Washington City Council
Regular Meeting Agenda
July 22, 2026

WASHINGTON CITY
CITY COUNCIL MEETING
STAFF REVIEW

ACTION REQUESTED: C-26-05 - Request for a Conditional Use Permit to redevelop the commercial property located at 910 & 912 west Red Cliffs Drive

SITE PLAN
GREENS SPRING SQUARE
LOCATED IN WASHINGTON, UTAH

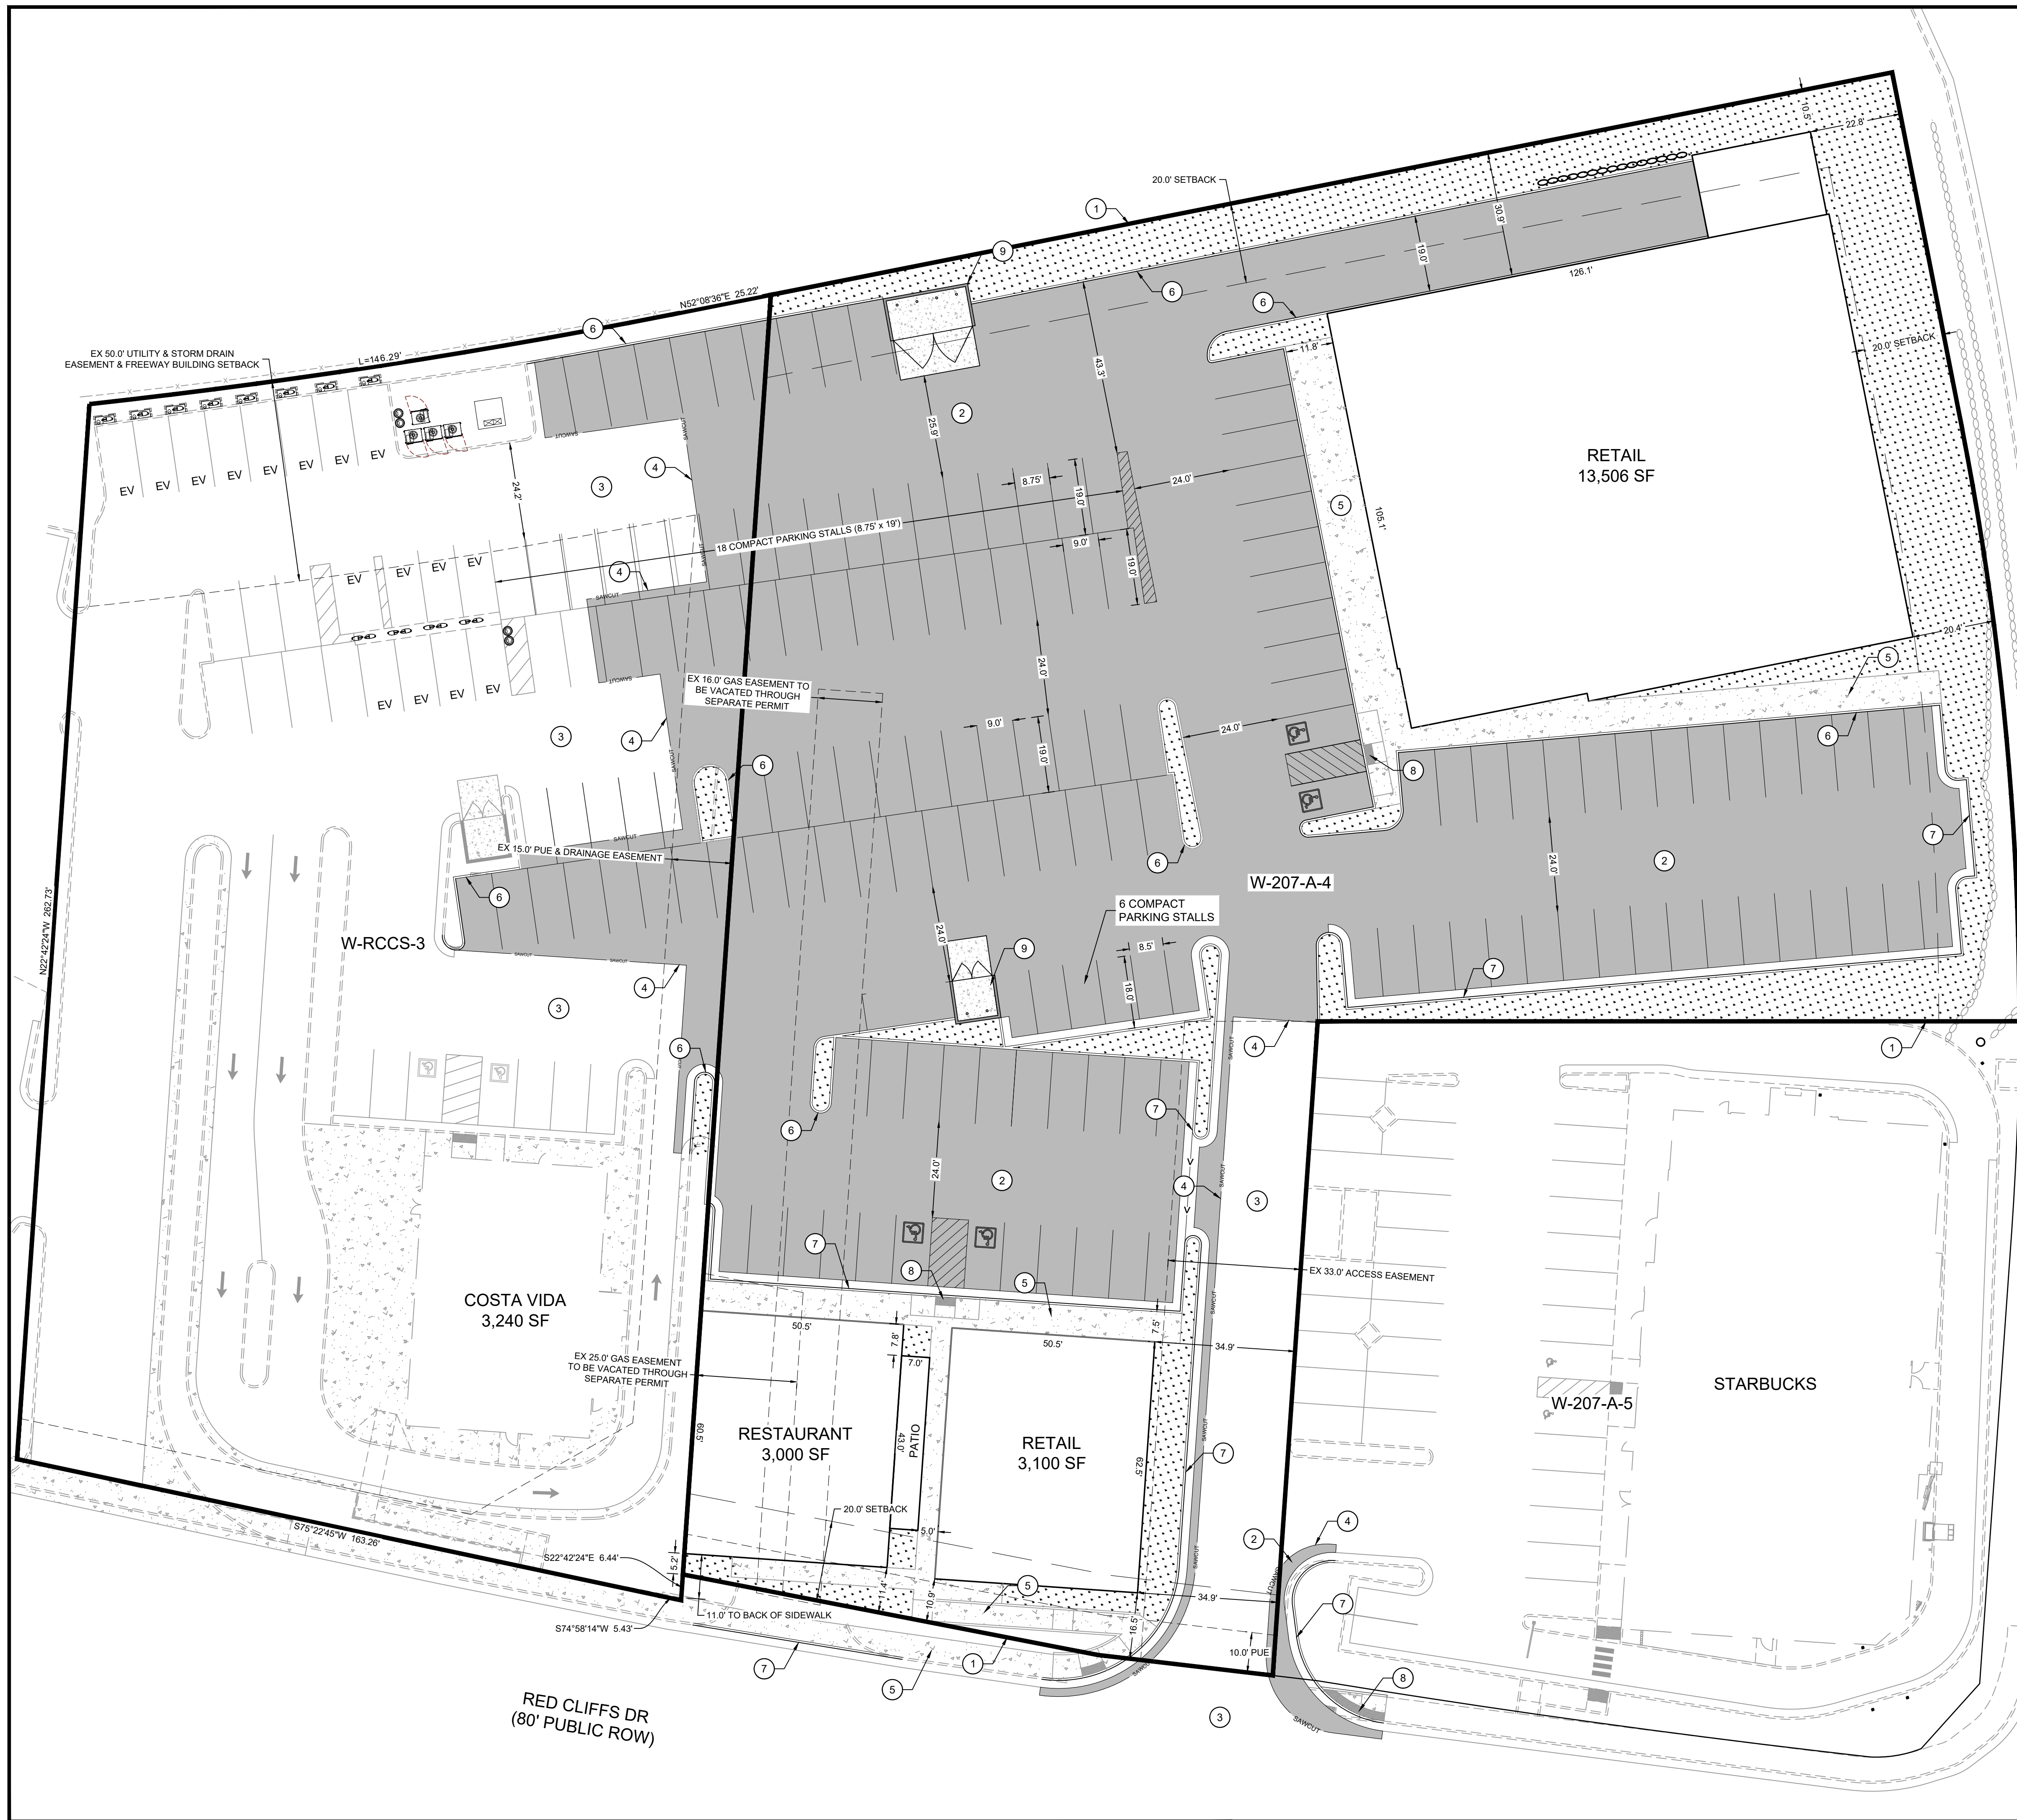
The required setback adjacent to Red Cliffs Drive is 20' feet. The applicant is encroaching this setback which will need to be approved by the City Council. The property line is angled at this location with the closest part of the building being 11' feet from the back of sidewalk (5' ft to property line) and 16' feet 5" inches to the farthest property line. The required side yard setback is 10' feet and the proposal is asking for this to be 0' feet. This setback will need to be approved by the City Council. Staff understands the need for the proposed setbacks and supports this

The proposed buildings require a total of 87 parking spaces. The proposal is providing 117 parking spaces 16 of which are for compact cars. The proposed parking is providing an excess of 30 parking spaces. The applicant is working on, and will be required to provide, a shared access agreement from the proposed development through parcel W-RCCS-3 which is where Costa Vida is located. This will allow better vehicular access from Red Cliffs Drive to the proposed development.

Community Development	Reviewed. OK to move forward. The applicant is asking for setback relief adjacent to Red Cliffs and the interior property line which staff supports. See staff report for details	
Planning	Review, Ok to Continue	
Public Works	Reviewed - Corrections for labeling existing easements and noting the abandonment of easements addressed. The utilities and access as shown are acceptable for the CUP but will require revisions in order for the civil construction drawings to be approved.	
Engineer	The "Restaurant 3,000 SF" Building is sitting on the existing 16' Gas Easement. No structures can sit on top of an easement. This will need to be resolved. I am assuming there is an access easement/agreement with all of the businesses (existing & proposed). This will need to happen or reference some documentation of this. Also, make sure that the plants behind the new retail and restaurant buildings don't present a sight distance problem.

12. Proposed buildings shall not encroach any of the existing utility easements. The existing gas easement shall be vacated prior to issuing the restaurant building permit.

13. The applicant is required to provide a shared access agreement from the proposed development through parcel W-RCCS-3 prior to issuing the first building permit.

14. The setbacks are approved as shown on the plan.

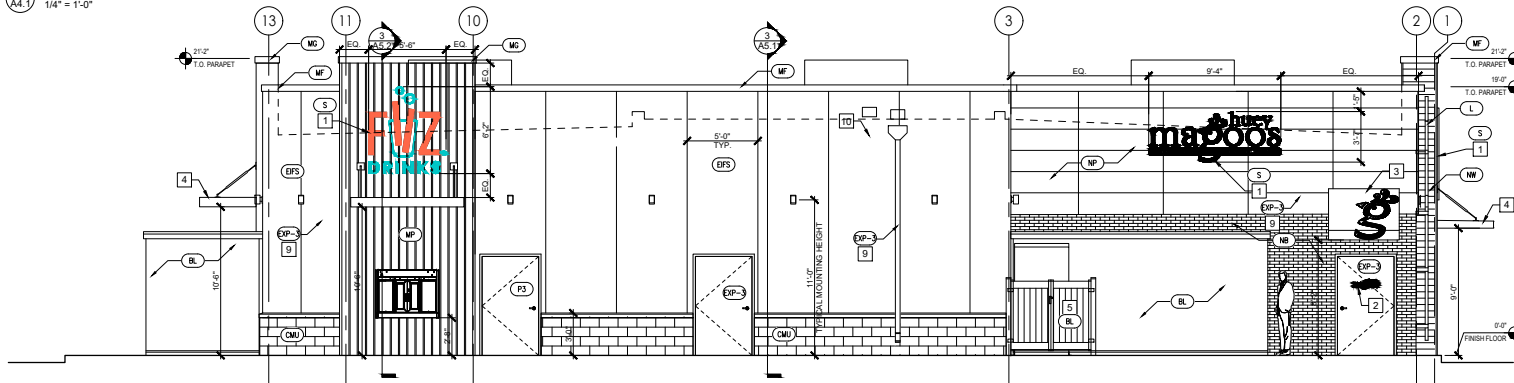
11. Construction drawings will need to be submitted for review and approval, prior to any work being done on the site. The applicant shall work closely with public works regarding the civil improvements for this development to ensure services are adequate and meet city requirements including the relocation of the shared parking. The west access point near the intersection of Twin Rocks and Hoodoo Way will require additional study and may need to be removed or revised to an exit only to help with traffic at the intersection.

12. Three landscape islands, with trees and live growth plants, shall be incorporated into the plan at the north end of the three proposed parking rows. This shall be verified during the Construction Drawing review process.

Community Development	Reviewed. OK to move forward	
Planning	Reviewed, OK to move forward	
Public Works	Reviewed. OK to move forward. The west access point near the intersection of Twin Rocks and Hoodoo Way will require additional study and may need to be either removed or revised to an exit only to help with traffic at the intersection. Base utility layout (water, sewer, storm) shown on this exhibit is fine for CUP but will need to be revised for civil construction drawing submission.	
Engineer	Reviewed and no major concerns	
Fire Dept.	Reviewed, OK to move forward	
Parks/Trails	Reviewed, no concerns	
Building Dept	Reviewed, OK to move forward	
Washington Power	Ok based on the CUP submitted. Will need to submit power requirements for the building with submittals.	
Economic Dev	Staff supports the proposed CUP. The project represents a quality commercial investment within the Sienna Hills commercial center and will further strengthen the Exit 13 trade area by adding new dining options, creating jobs, and enhancing services for residents and visitors. The development is consistent with the vision and intent of the Sienna Hills PCD.
